BATTERY POSITION/1980 XLH, XLS

ILLUSTRATION 1
BATTERY CARRIER WITH PADS INSTALLED

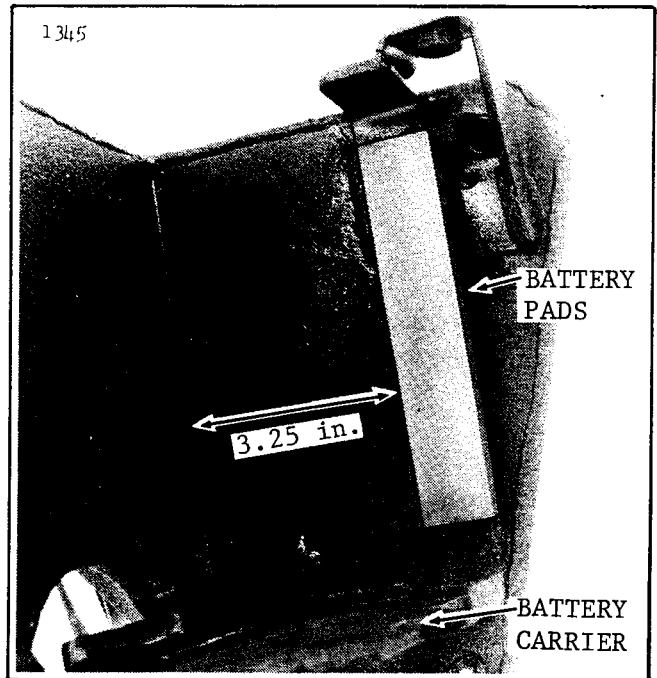
The batteries of some 1980 XLH, XLS motorcycles have been mispositioned within the battery carrier. The pad the battery rests on is thick enough to allow the battery to be pushed over the carrier retaining edge until the battery vent fitting is flush against the oil tank. In this position, the vent fitting could break.

Check all 1980 XLH, XLS vehicles between VIN's 3A 10000 JO to 3A 18419 JO and 4E 11137 JO to 4E 18482 JO for this condition. Perform the recommended fix when necessary.

This condition should be corrected as follows. Remove the seat to expose the battery and carrier and then remove the battery. Take two (2) battery cover pads, Part No. 66352-65, which have adhesive backing on one side, and glue them together. Then attach pads to the oil tank in front of the vent fitting position in the carrier. (Approximately 3.25 inches from inside wall.) (See Illustration 1.) This will effectively space the battery away from the oil tank.
